Subject: Proposals for the Cambridge South East Transport busway and public rights of way

I am contacting you in my capacity as Group Secretary of the Cambridge Group of the Ramblers, a statutory consultee for developments affecting public rights of way.

Response to request to provide comments on Cambridge South East Transport Scheme, Transport and Works Act Order – draft order documents 1.1 18 Nov 2024, by Cambridge Ramblers. 6 Dec 2024.

Figure 1

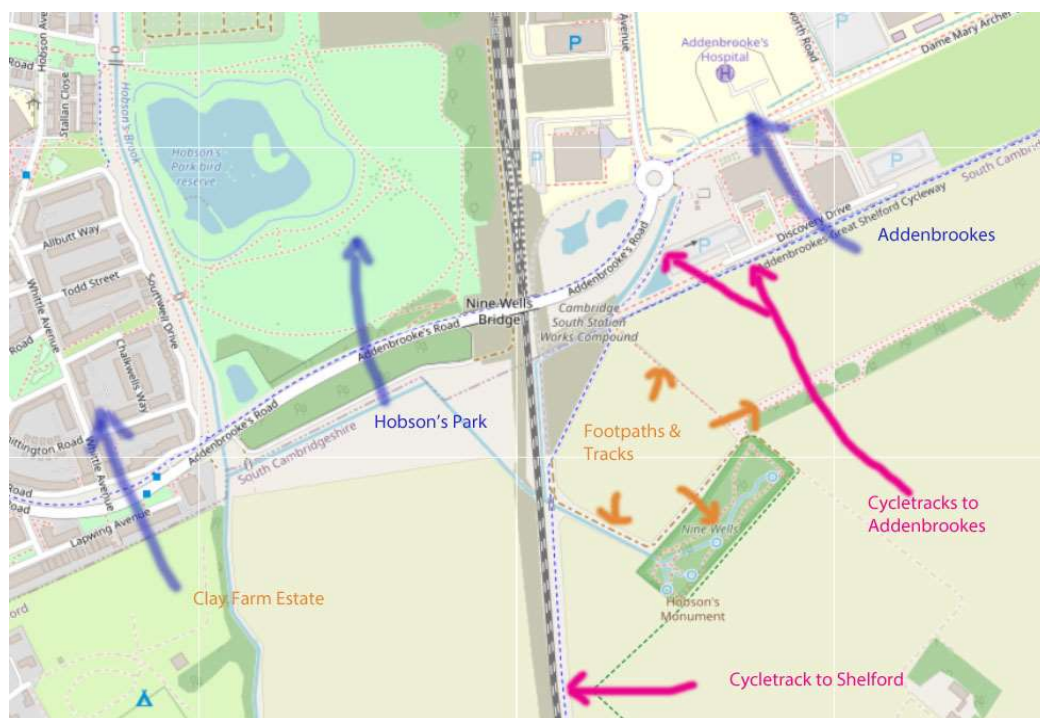
1.2 In particular, from looking at the Rights of Way plans in the draft TWAO (in particular CSET-11-DO4-00_Rights of Way & Traffic Regulation Plans) it appears that the proposal is to prevent walking between the Nine Wells Local Nature Reserve and both the Bio-Medical Campus and Shelford. Currently these connections are provided by the DNA cycletrack, but they do not appear to be reflected in the busway plans in the draft TWAO. We trust that this is not a deliberate policy but merely results from the lack of impact assessment of the needs of walkers.

1.3 If left to stand as proposed, it would mean that Bio-Medical Campus users would be denied access to the Local Nature Reserve. It would also mean that leisure and active travellers between Shelford and Cambridge would be forced to give up the rural Nine Wells route and solely walk on roads and tarmac. In addition there would be no access to Nine Wells from Hobson's Park or the Clay Farm housing estate.

1.5 The following map (based on OpenStreet Map) shows the footpaths and tracks currently used and which would become unavailable if the proposals were put into practice.

Figure 4

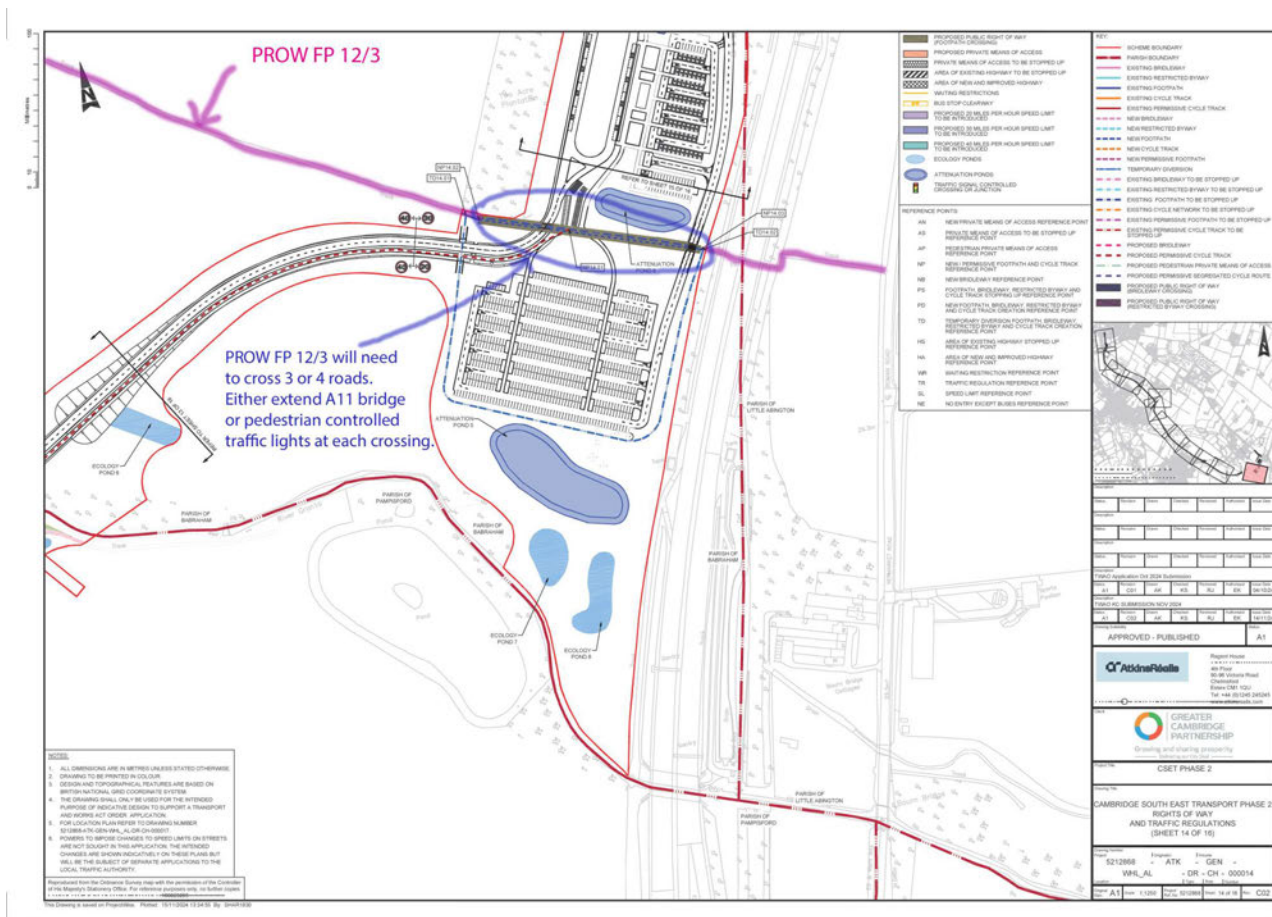
3.2 However, in the proposed design, it appears that the footpath (FP 12/3) now needs to cross 3 or 4 roads. This appears to be both unsafe and inconvenient for both footpath users and vehicle drivers. We suggest that the design should revert to a much narrower crossing, two roads only, which would reduce the length of any extension to the bridge (if implemented) or width of pedestrian crossing. See comments on below map.

Figure 5

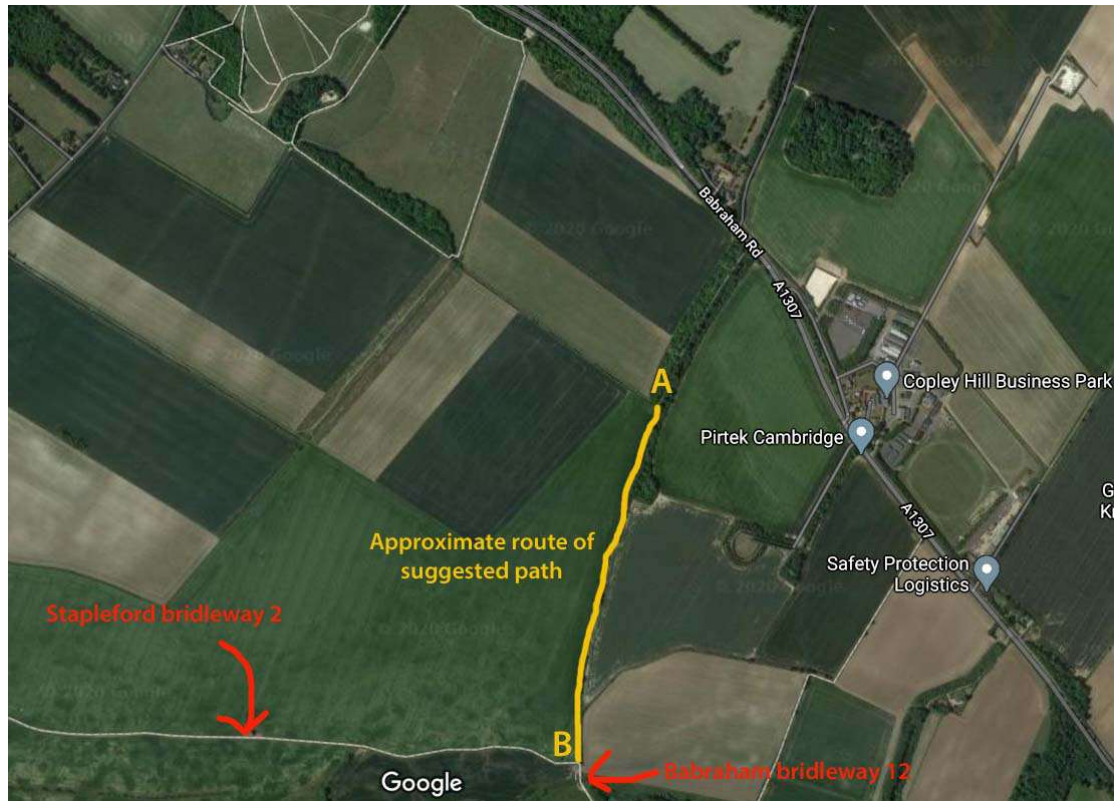
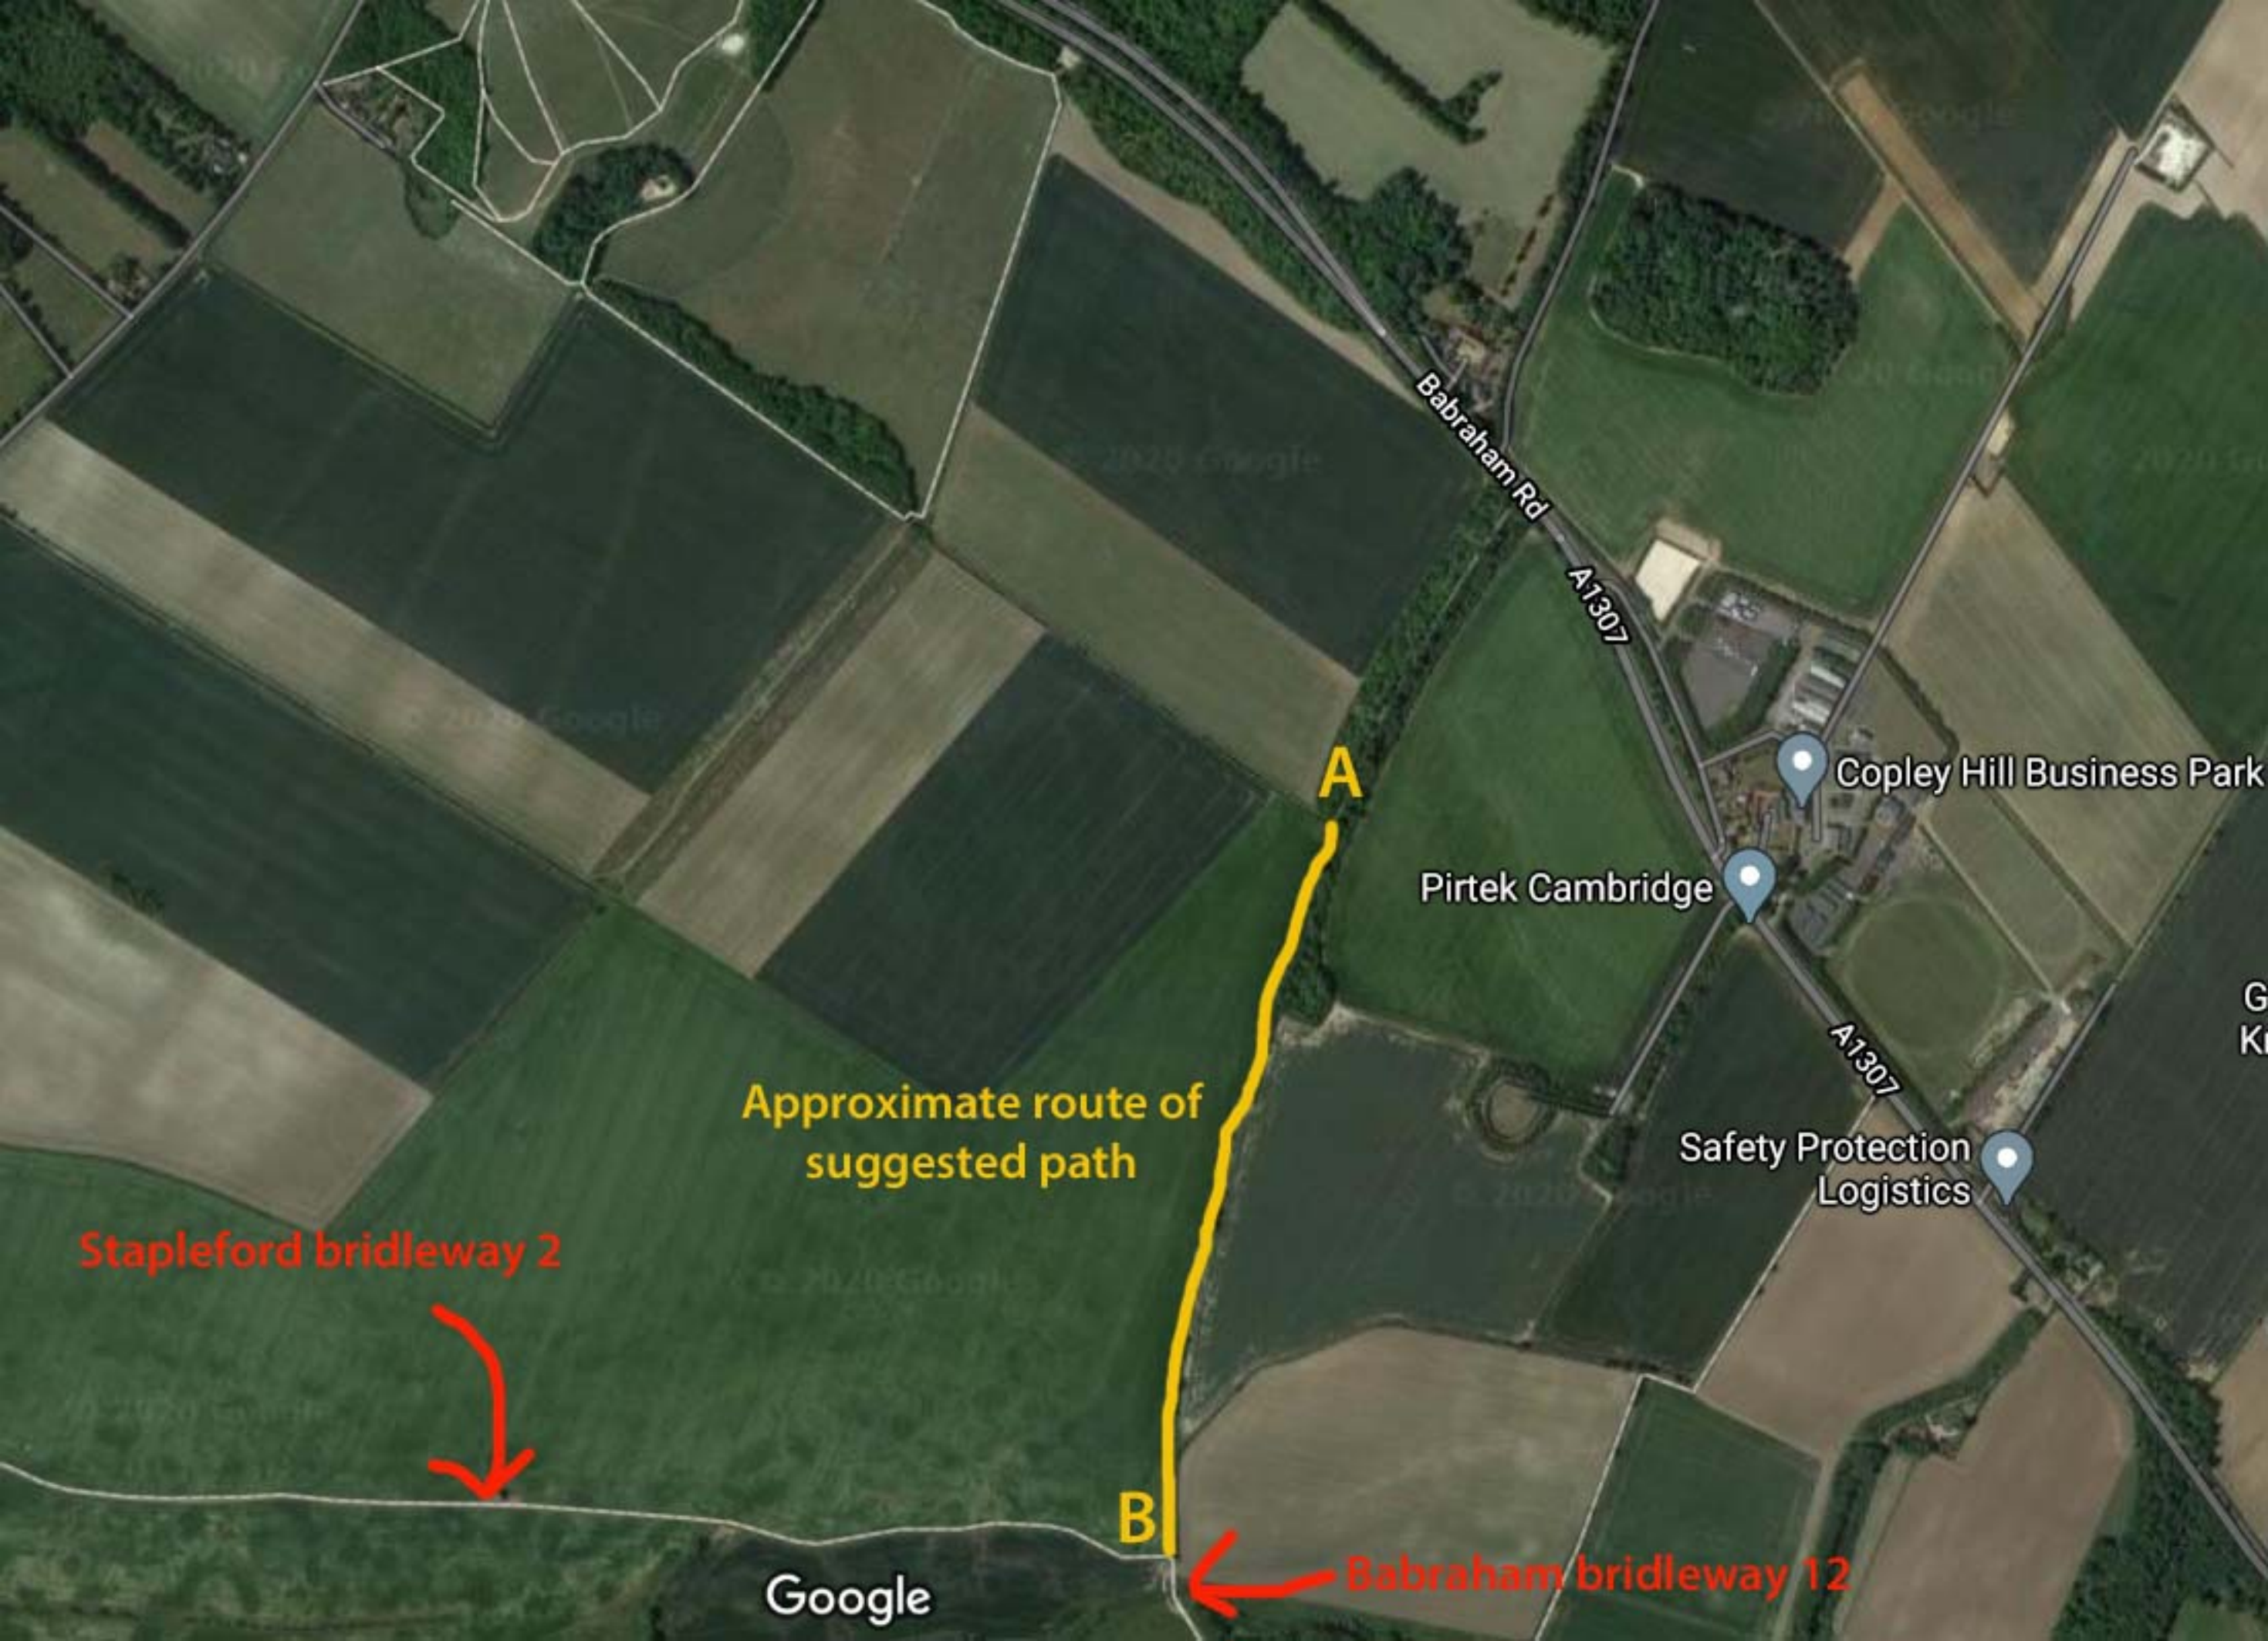
5.1 **Additional footpath.** In the 2020 consultation we were asked for any suggestion on footpath improvements. We made the following suggestion for a link path between Babraham bridleway 12 and Gog Magog.

Approximate route of
suggested path

PROW FP 12/3

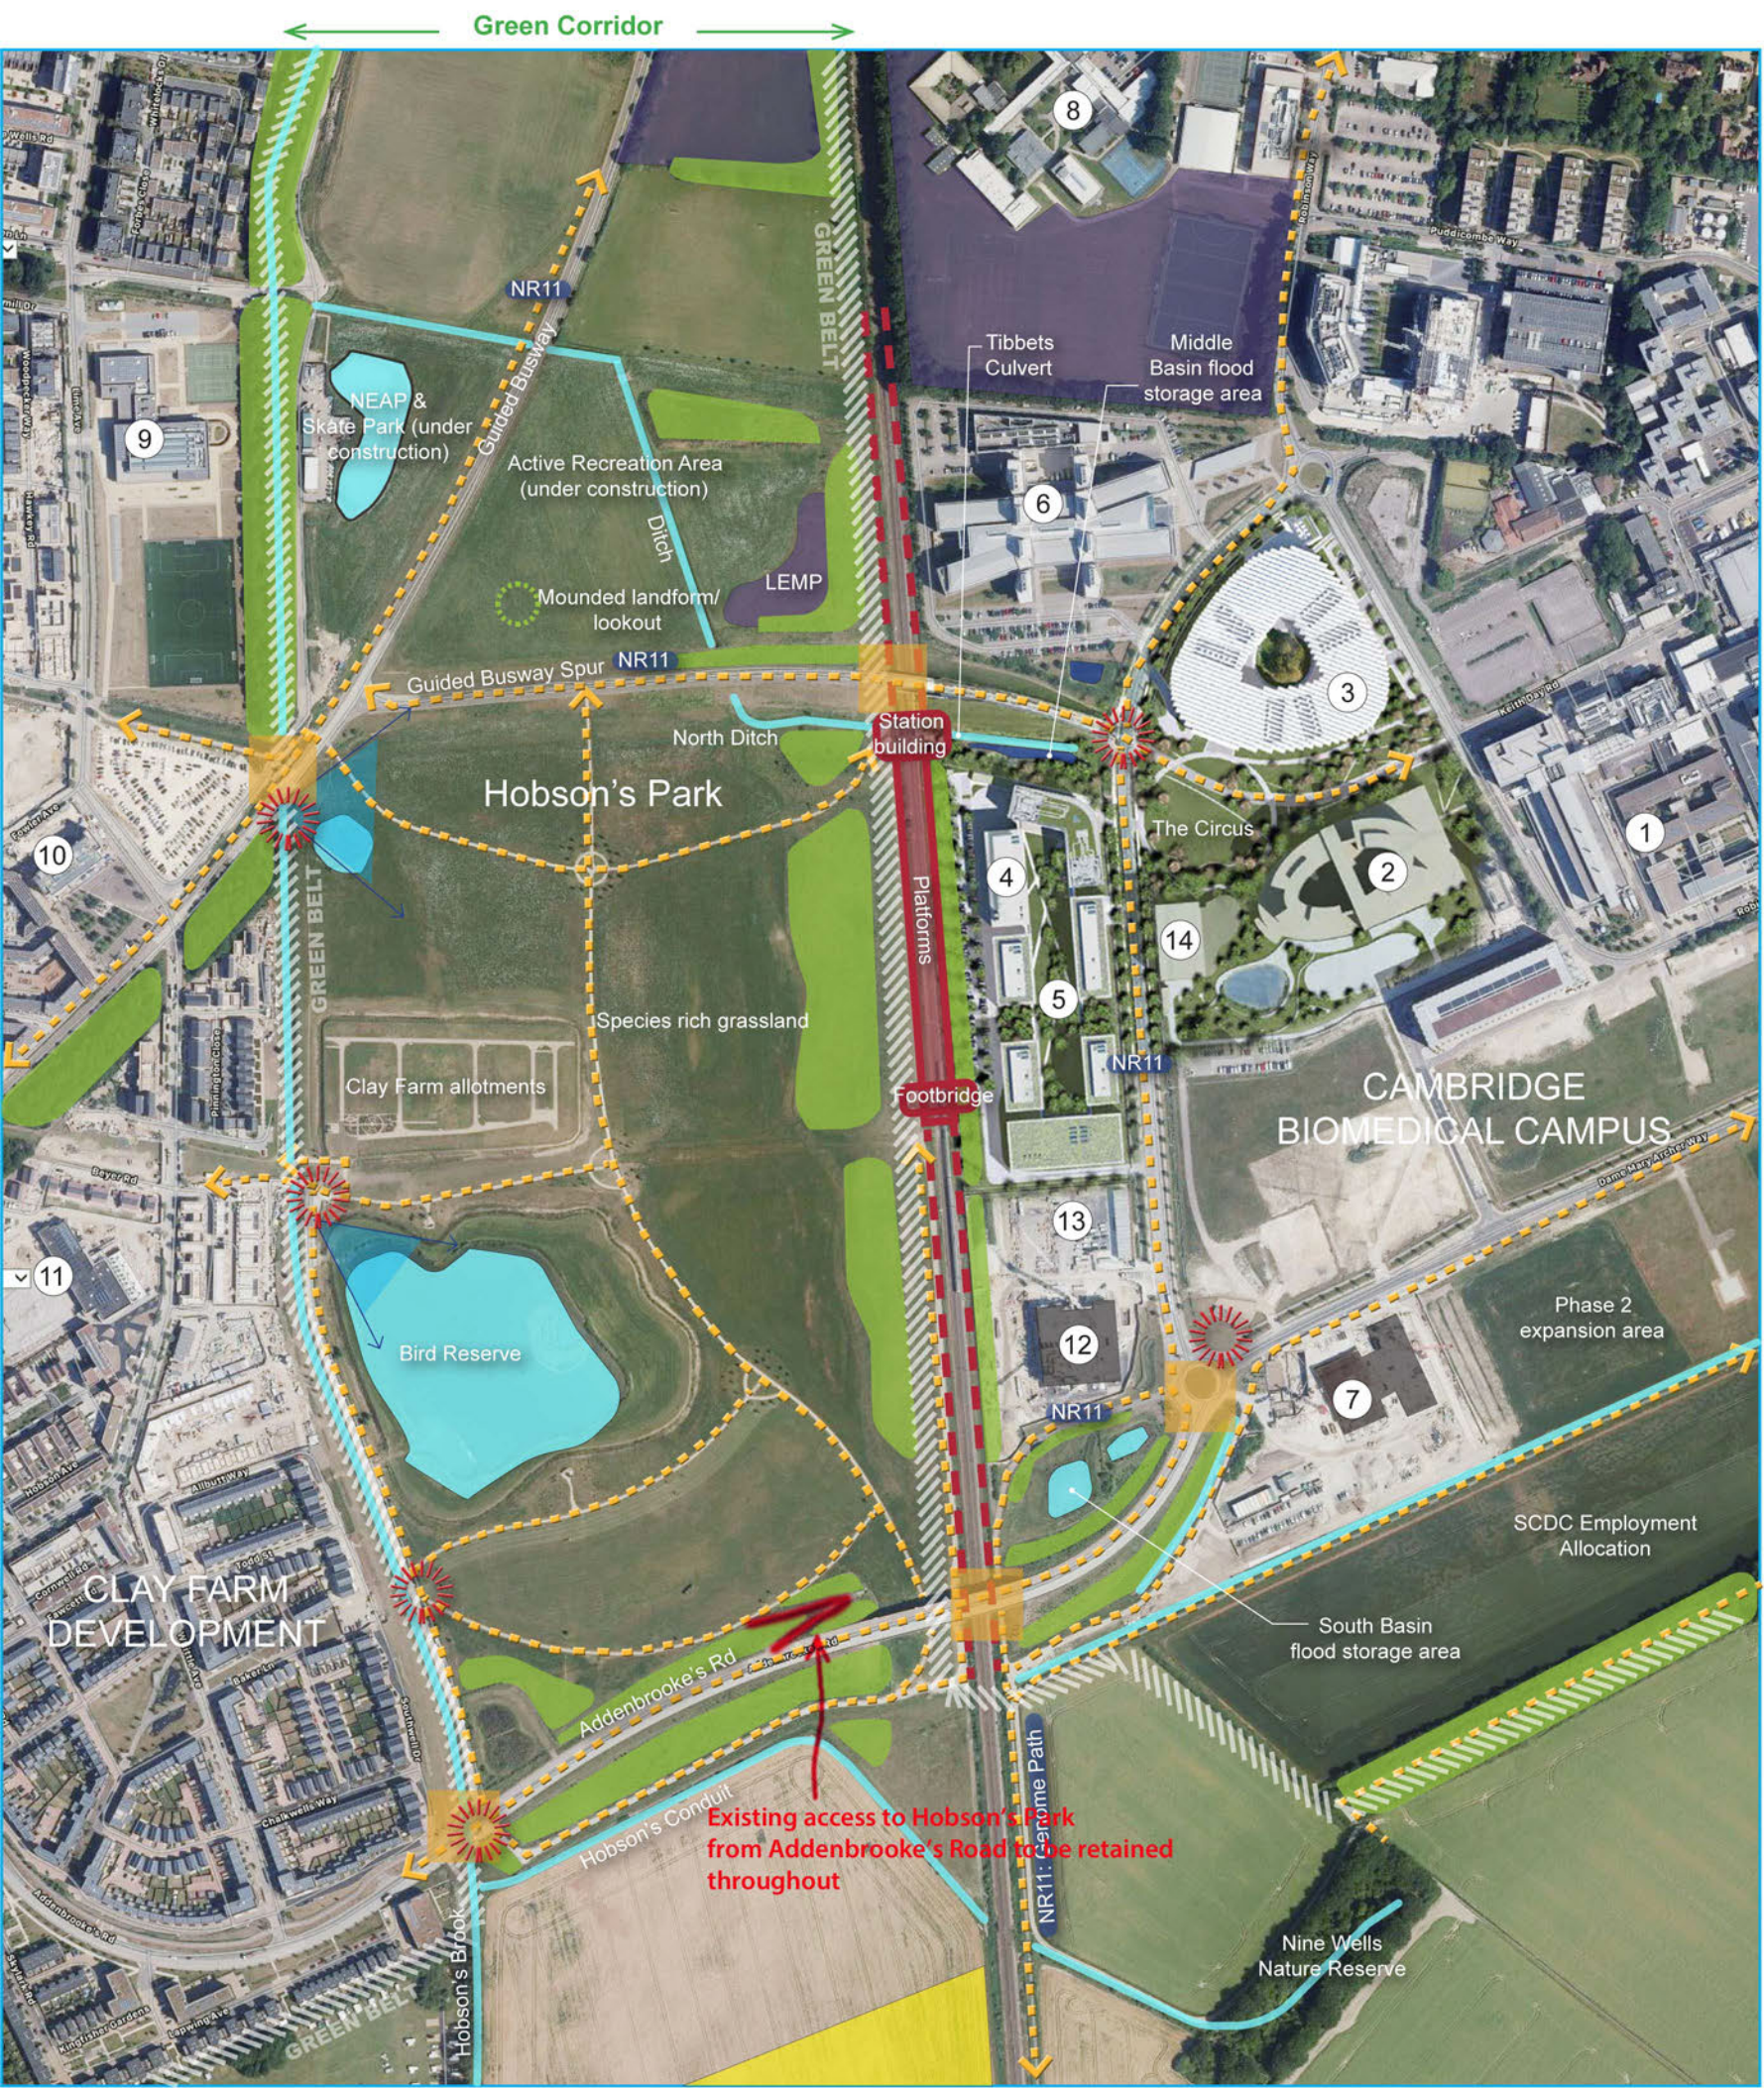
PROW FP 12/3 will need to cross 3 or 4 roads. Either extend A11 bridge or pedestrian controlled traffic lights at each crossing.
